-2		-1		ITEM NO.	PART OR IDENTIFYING NO.	NOMENCLATURE OR DESCRIPTION
QTY REQD						
PARTS LIST						
INIT	APPROVALS	DATE	INIT	APPROVALS	DATE	<h2>Modelgården</h2> <p>TITLE Flytbar flise 300 X 510 x 54</p>
CONTRACT NO.			MATERIAL		SIZE	
			FINISH		CAGE CODE	
			TREATMENT		DWG NO.	
NEXT ASSY			USED ON		REV	
APPLICATION			SIMILAR TO		SCALE	
					SHEET

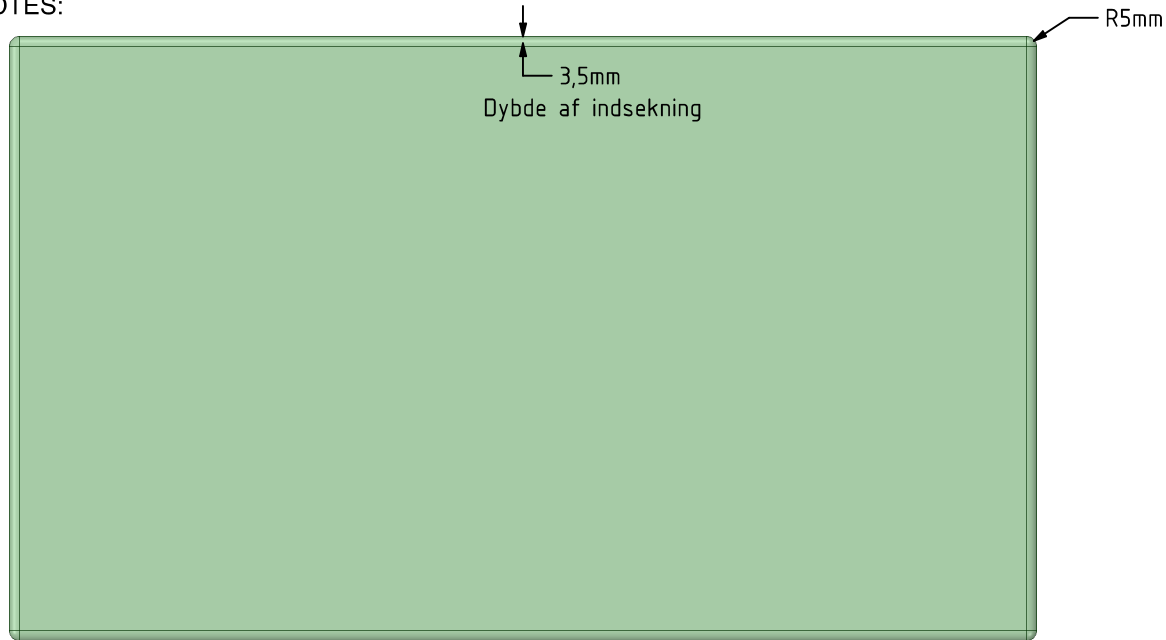
Gummiform laves 53 mm høj, så jernramme kommer til at stikke 1 mm op over gummi
